RBH9928-2 TAB BENDER

DART AEROSPACE Hawkesbury, Ontario, Canada		
TITLE: CLAMP		
DWG NO.: RBH9928-2-3 REV K		
DESIGN BY:	VM 9/22/2017	FRACTIONS ± 1/8
DRAWN BY:	WM 11/15/2017	XX ± .01 ANGLES ± 5°
X	.1	SURFACES = 125
CHECKED:	WM 11/15/2017	1. DIMENSIONS ARE IN INCHES UNLESS OTHERWISE SPECIFIED
MFG. APPR.:	DP 11/16/2017	2. INTERPRET DIM AND TOL PER ASME Y14.5M-2009
APPROVED:	WM 11/16/2017	3. DIMENSIONAL LIMITS APPLY AFTER PLATING
DATE:	11/15/2017	
SCALE:	NTS	WEIGHT: 0.2 LBS
		SHEET 3 OF 3

WORK ORDER NON-CONFORMANCE / ROUTE UPDATE

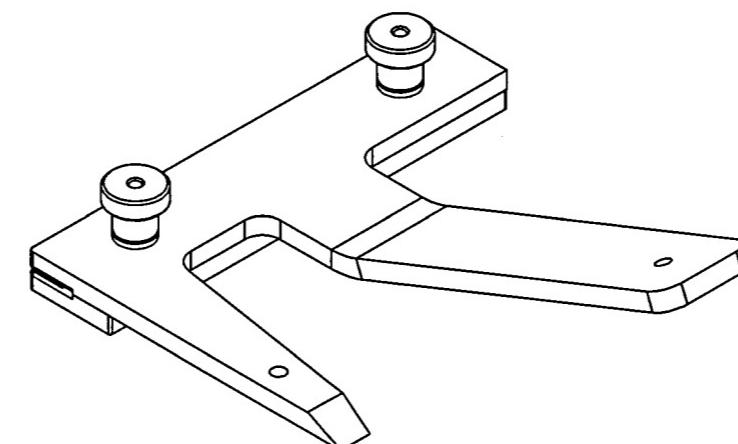
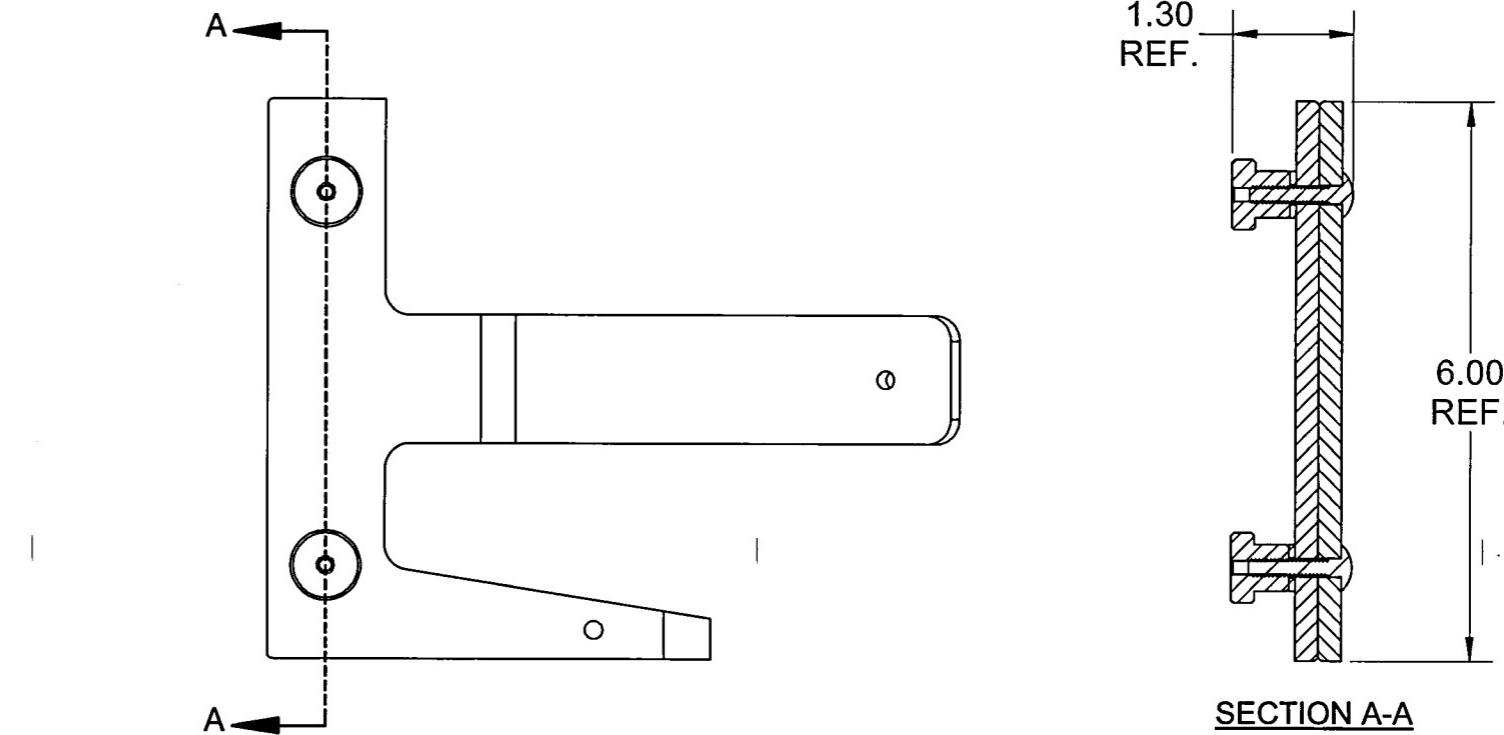
REV.	DESCRIPTION	ECN #	DATE	BY	APPROVED
9	SEPERATED FROM RBH9928	-	6/5/13	BIM	EB
10	-1 CH'D DISTANCE OF RADIUS FROM .500 (X2) TO .670 (X2). -3 CH'D DISTANCE OF RADIUS FROM .625 (X2) TO .670 (X2). CH'D NON-CRITICAL DIMENSION PRECISION FROM XXX TO XX.	-	7/31/13	RJC	GE
K	TEMPLATE UPDATED AS PER HAWKESBURY STANDARDS, -3 DRILL AND BROACH DIMENSION CHANGED, -1 & -3 RADIUS ALONG THE EDGE DIMENSIONS ADDED, TOLERANCE ADDED ON -1 & -3	17-669	17.09.22	VM	WM

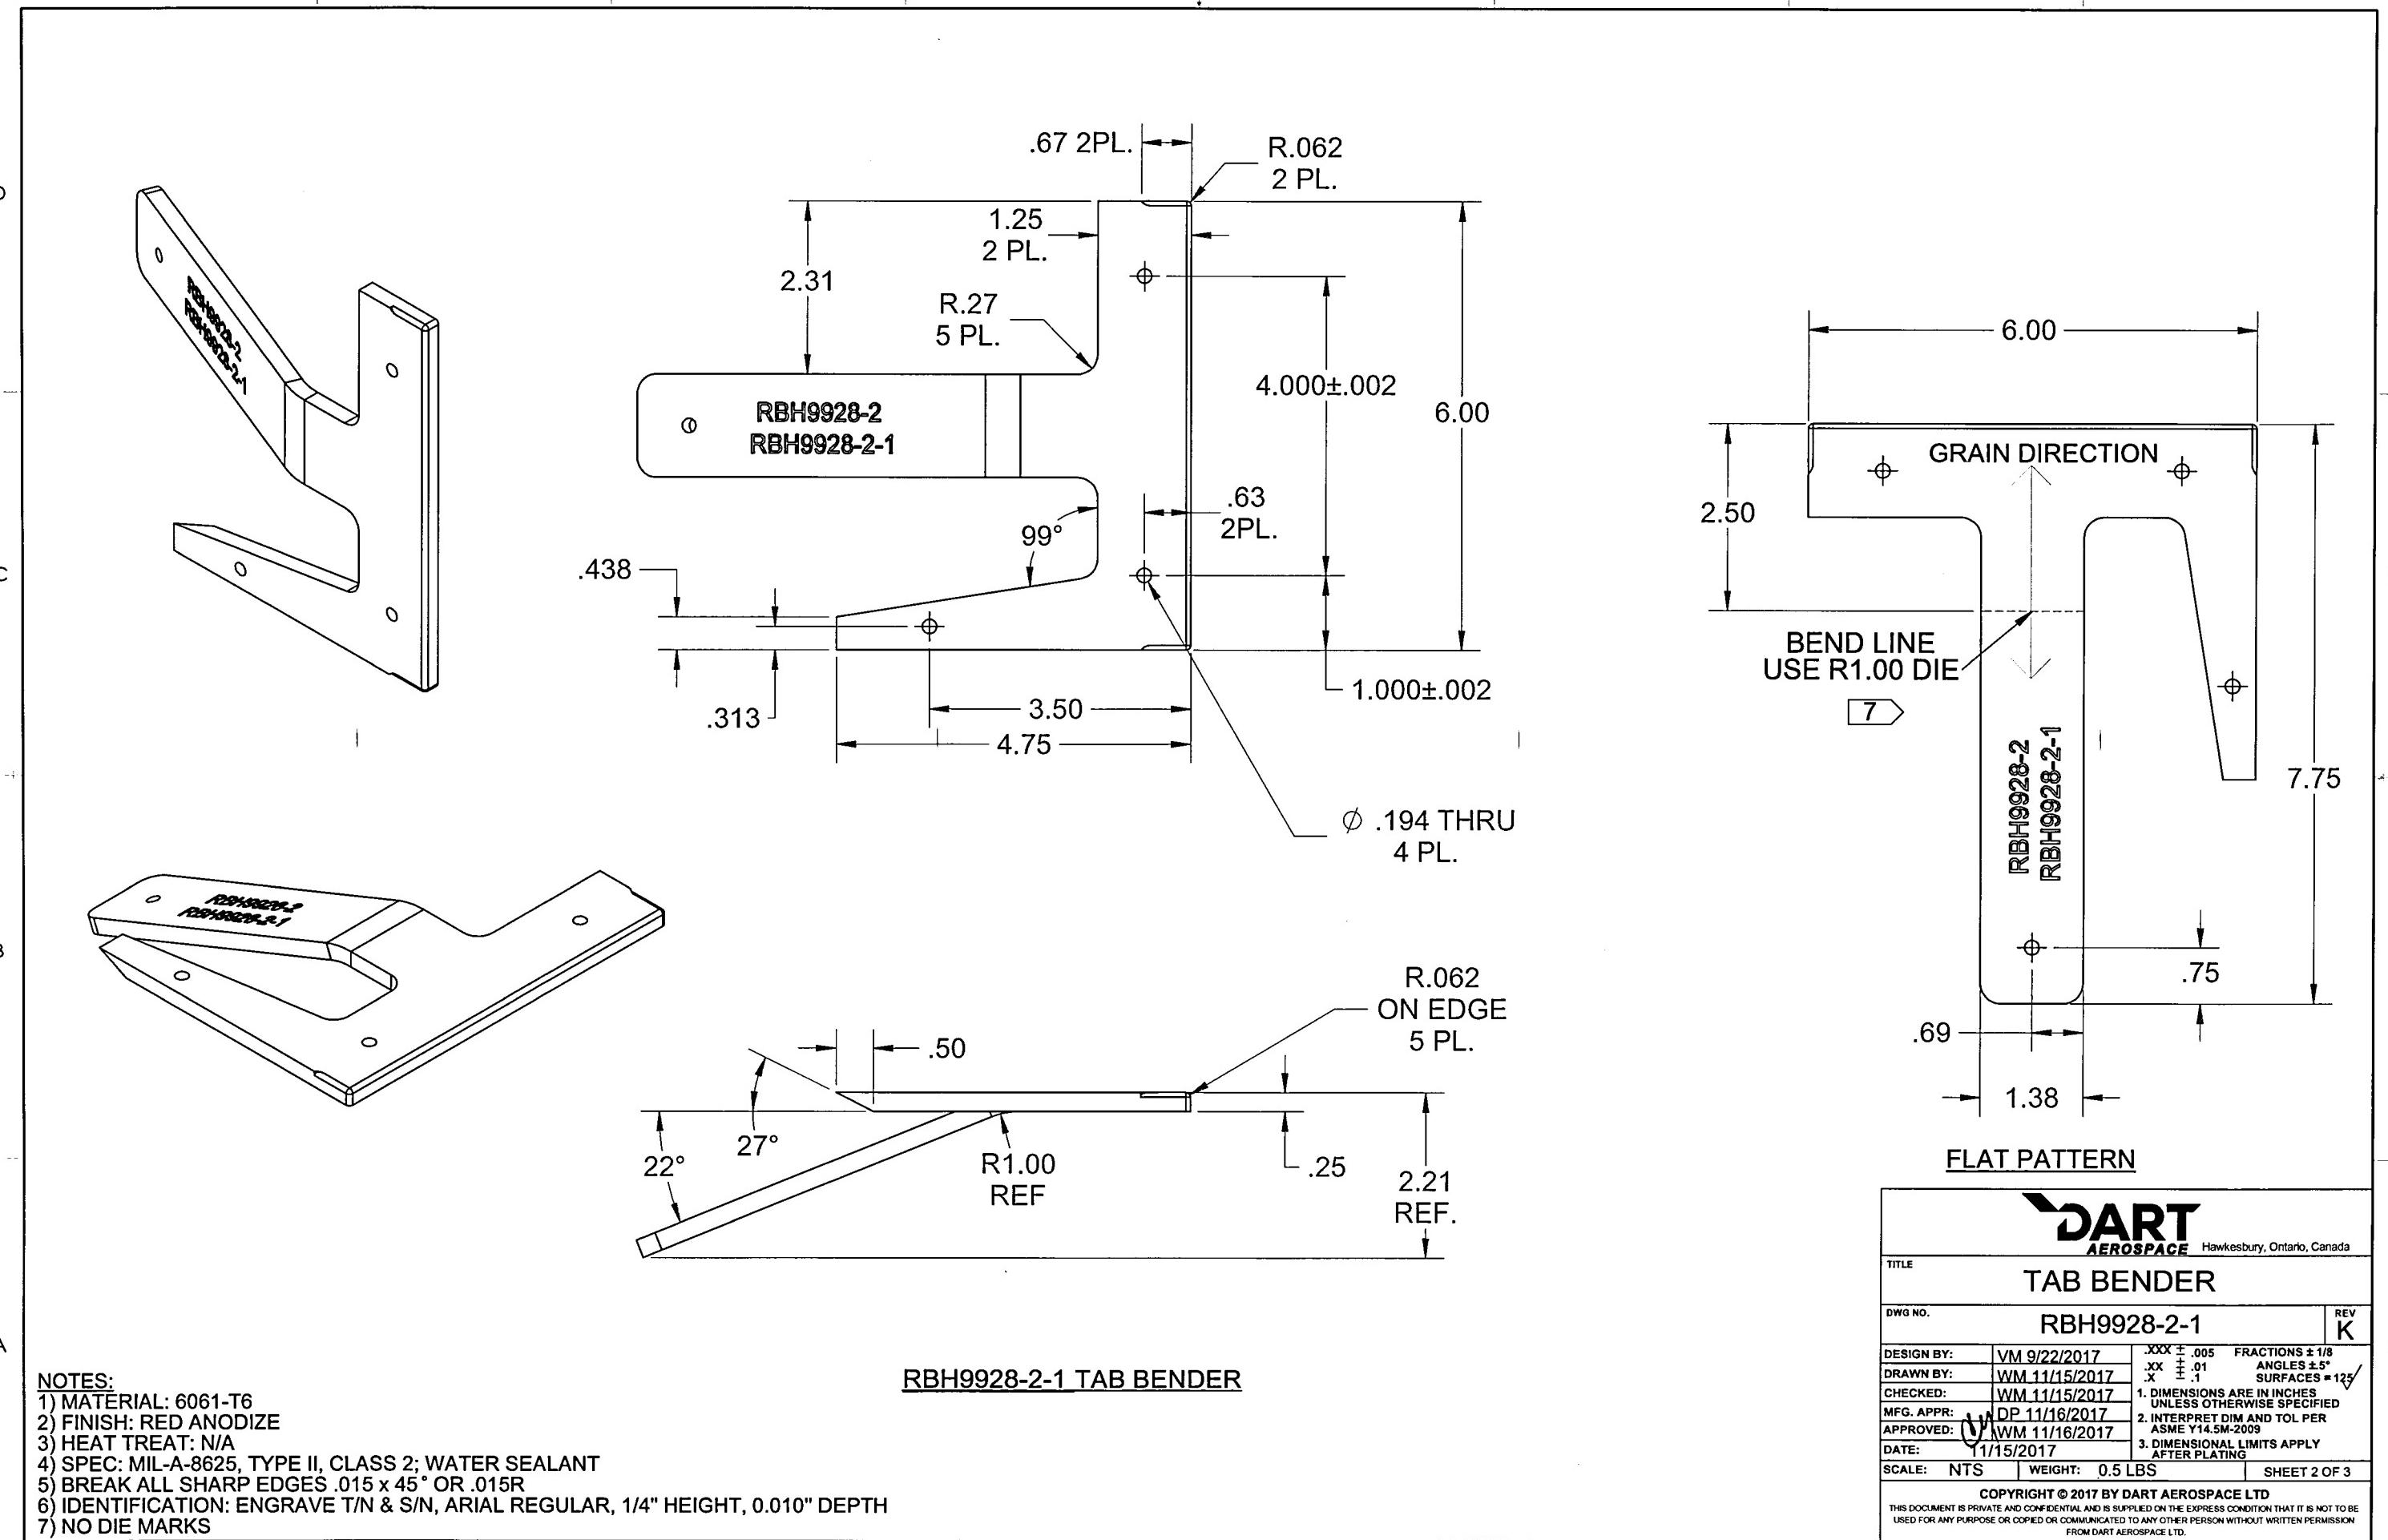
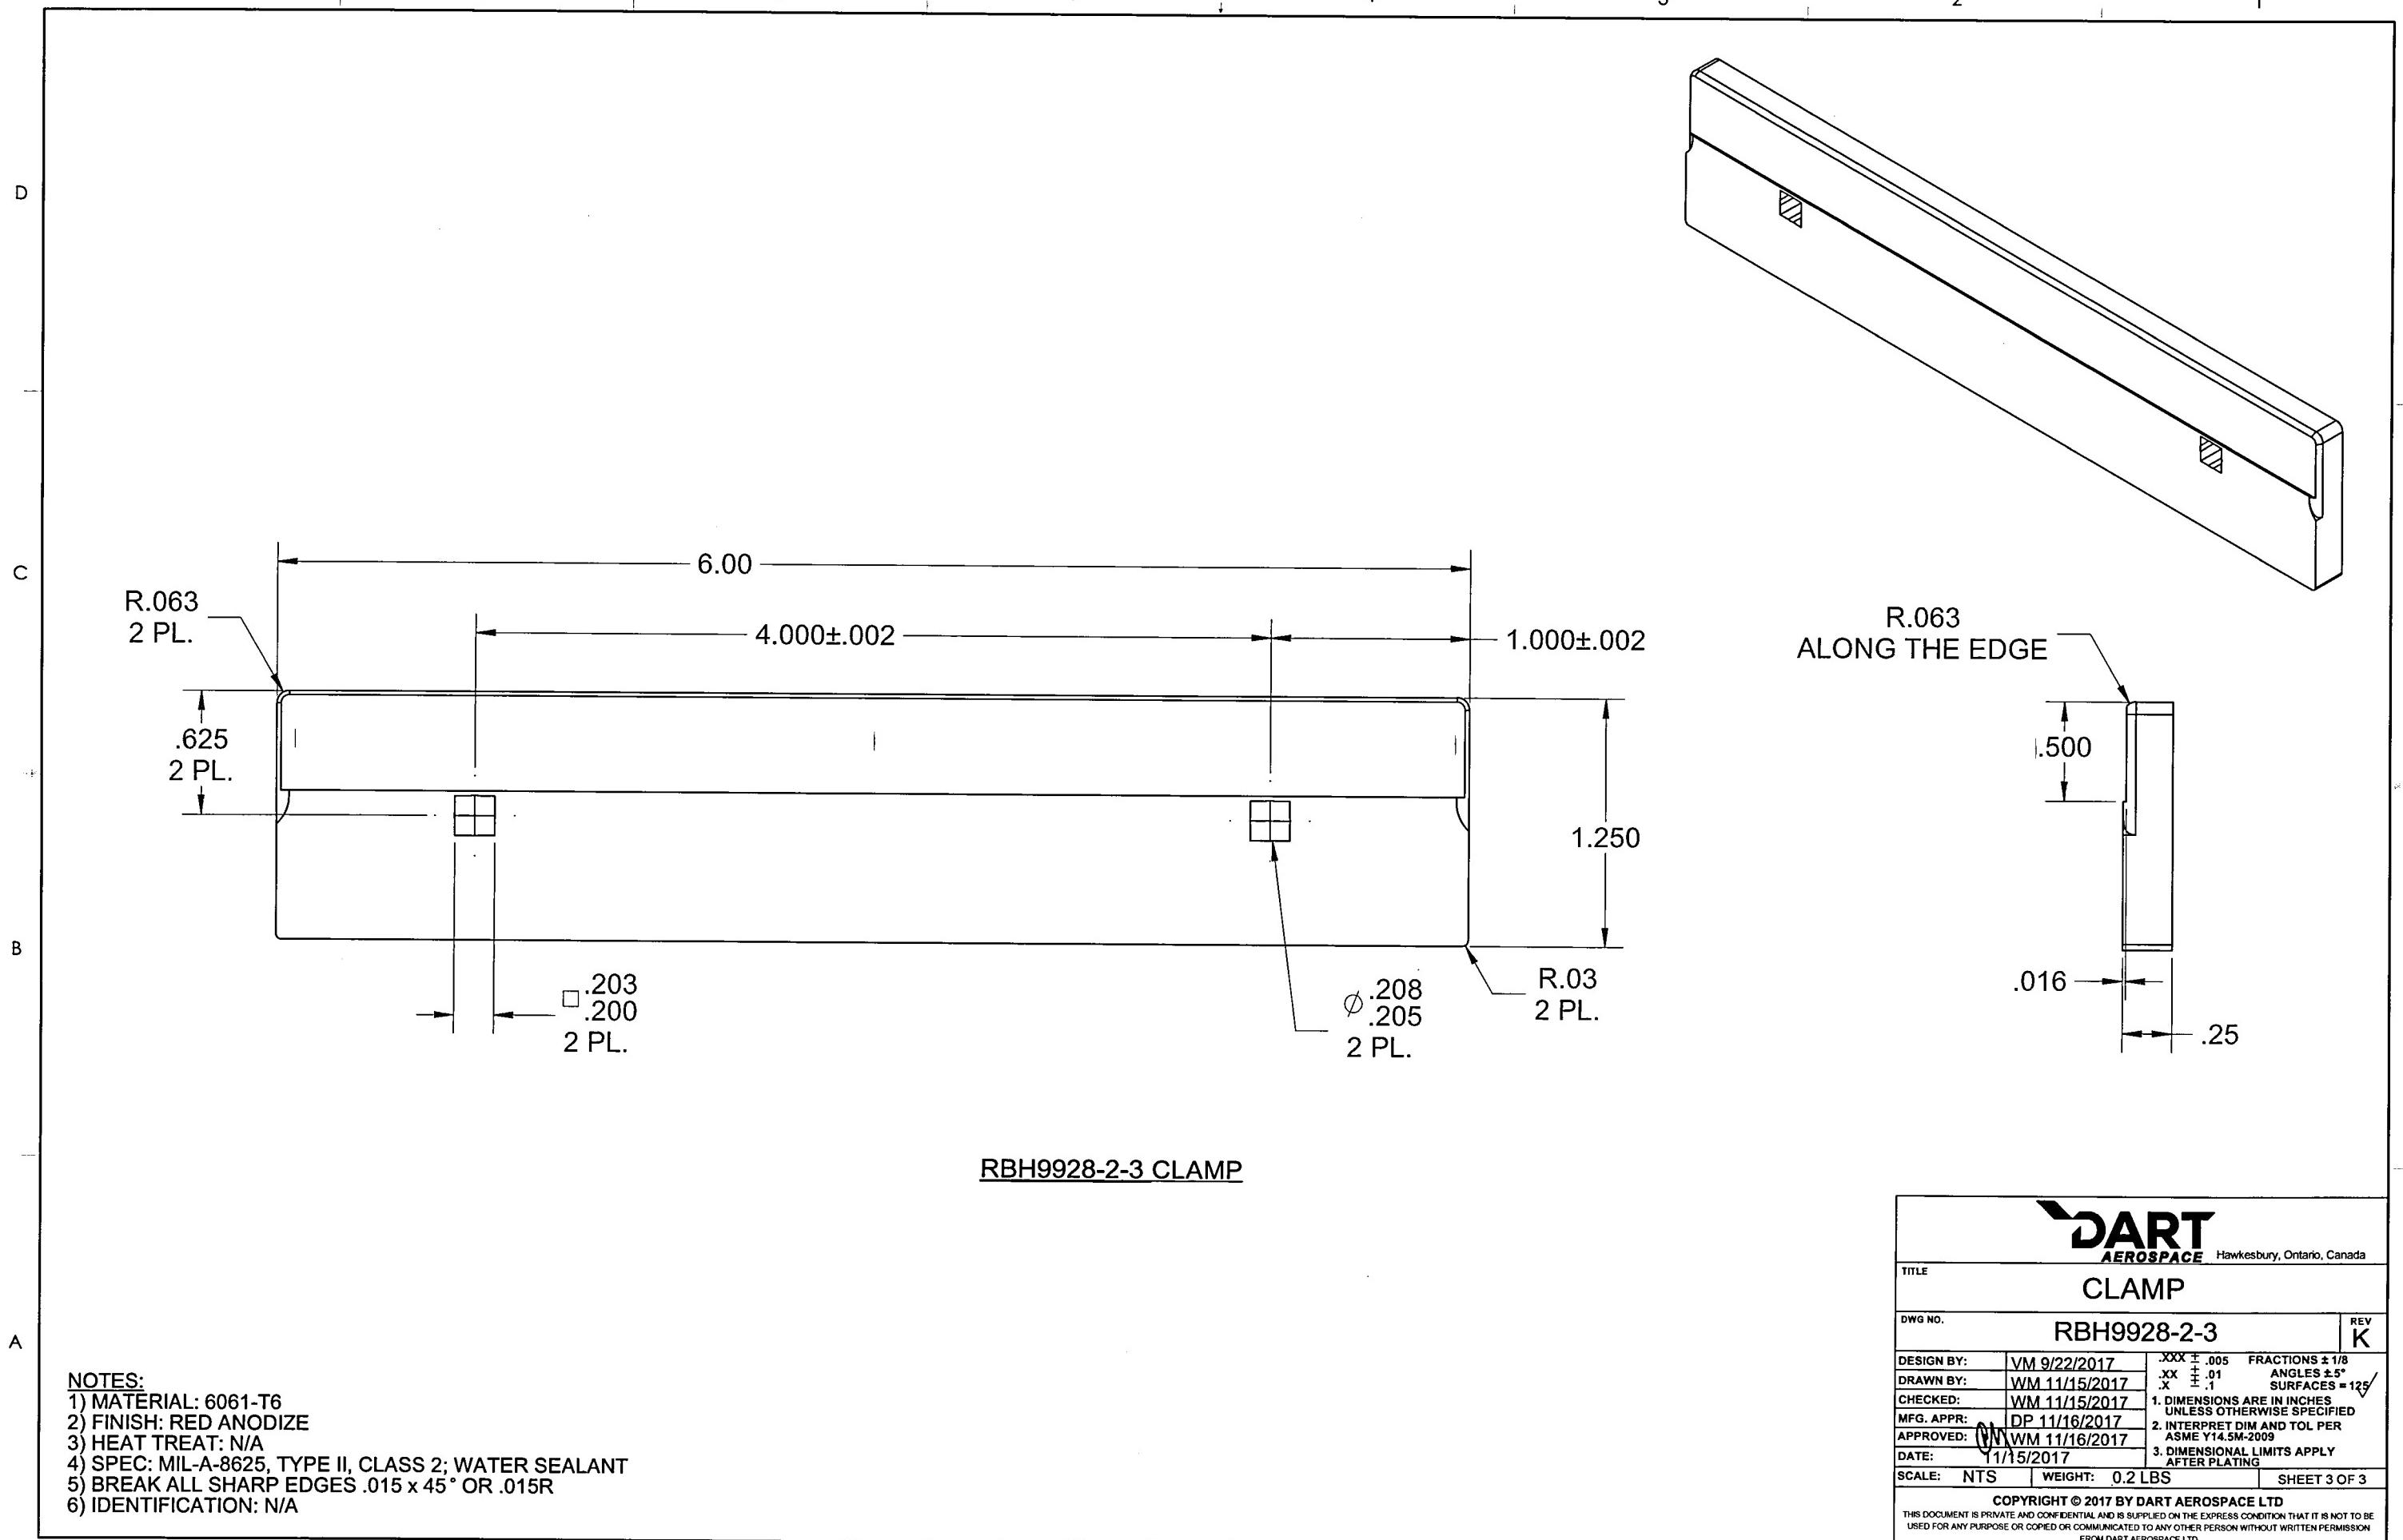
Job: <input type="text"/> Part No. <u>RBH9928-2-3</u>		DISPOSITION	DEPARTMENT/PROCESS			
		Rework Scrap Use-as-is	Skid-tube Machining Large Fab	Cross tube Small Fab Finishing	Eng. (Non-AW) Prod. Eng. Coor. Rec/Store/Packaging	Engineering Water Jet Supplier Quality
Date : <u>2019-08-14</u>	Sequence #:	QTY Affected :			MRB (Q91042) 	
Description Work Order Deviation		Disposition				Completed By
DIMENSION <input type="checkbox"/> 0.200/0.203 CAN BE BROACH AT <input type="checkbox"/> 0.188		THIS DEVIATION IS ACCEPTABLE TO USE AS IS FIT, FORM AND FUNCTION WILL BE AS ORIGINALLY INTENDED				Lead hand / Supervisor
Root Cause		FAULT CATEGORY				QC / QA Coordinator
Operator	<input type="checkbox"/>	Pressure/Forced	Contamination	Power Loss/Surge	Positioned Wrong	
Manufacturing Process	<input type="checkbox"/>	Bending	Misaligned/off center	Folio/Program	Outside Tolerance	
Equip/Tooling	<input type="checkbox"/>	Crushing	BOM/Route	Grain Direction	<input checked="" type="checkbox"/> Drawing

Handling/Preservation	<input type="checkbox"/>	Cracks	Broken/Damage/Defect	Weld	Finish	
Material	<input type="checkbox"/>	Crimp/Kink/Ripple/Wave/Twist	Incomplete/Unclear Instructions	Wrong Stock Pulled	Part Lost/Missing	
Product Improvement	<input checked="" type="checkbox"/>	Marks/Chatter	Drill Holes	Out of Sequence	<input type="checkbox"/> Misread	
Process Improvement	<input type="checkbox"/>	Mislabeled	Fit/Function	Off-set/Set-up		
Human Factors	<input type="checkbox"/>	Other/Details:
